## **ADDENDUM – PACKAGE 2**

251200 – PACKAGE 2  
Leander ISD Multicampus Kitchen Replacement  
Leander, Texas  
O'Connell Robertson Project No. 2512.00

Addendum No. 1

Addendum No. 1  
Date: 05.05.2026  
241400

#### **ITEM F1            Sheet K1.1 – Architectural Site Plan**

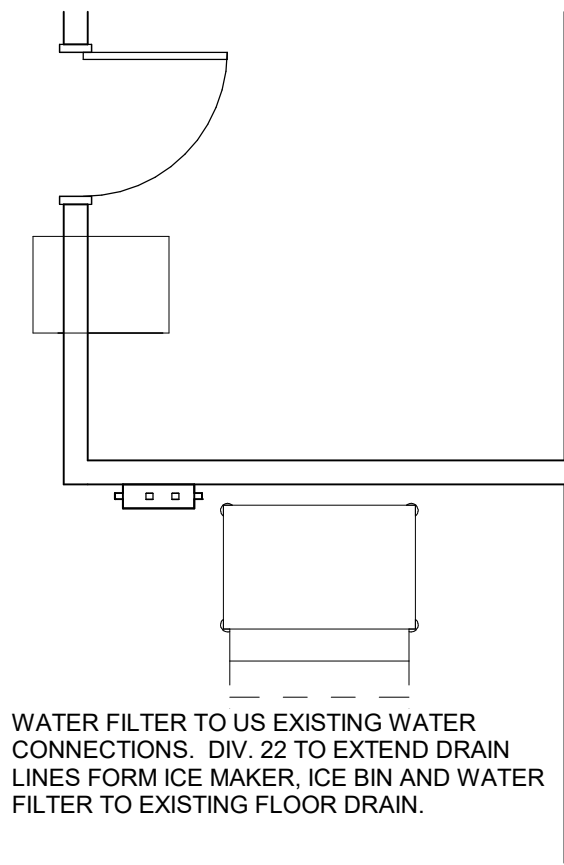
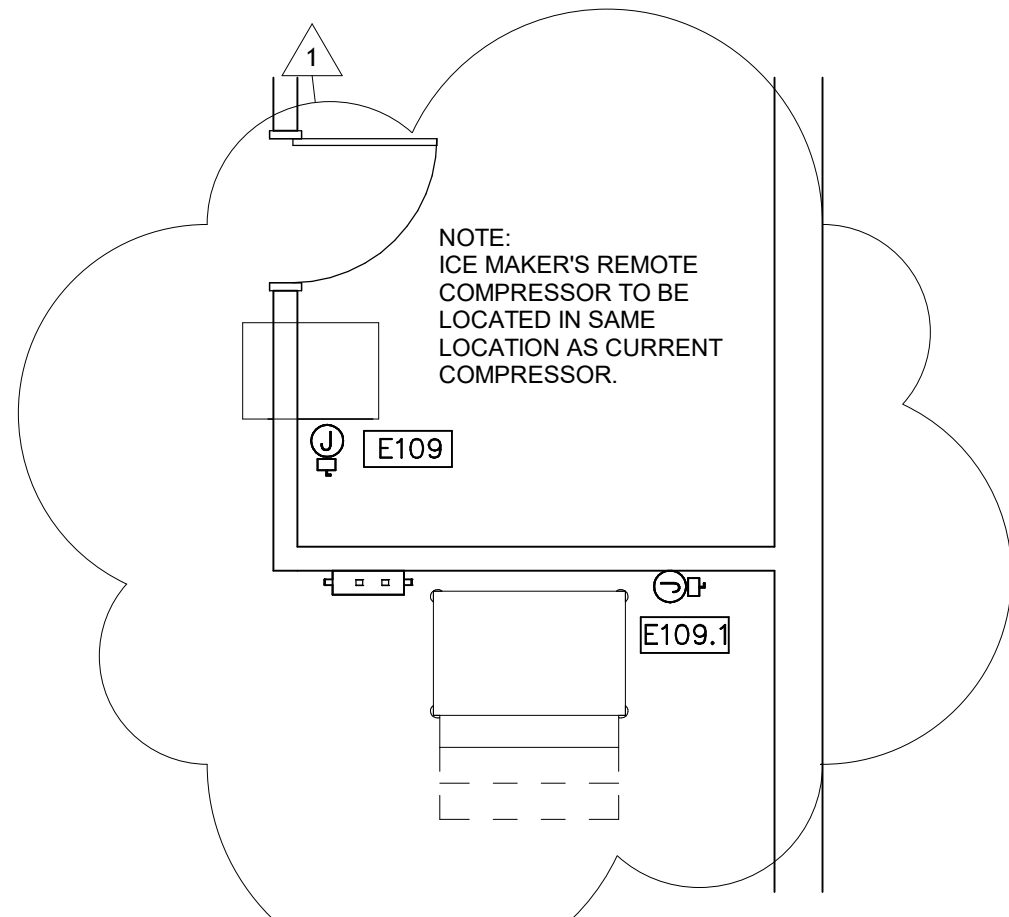
- A.** Clarified fence extents
- B.** Updated detail call out reference
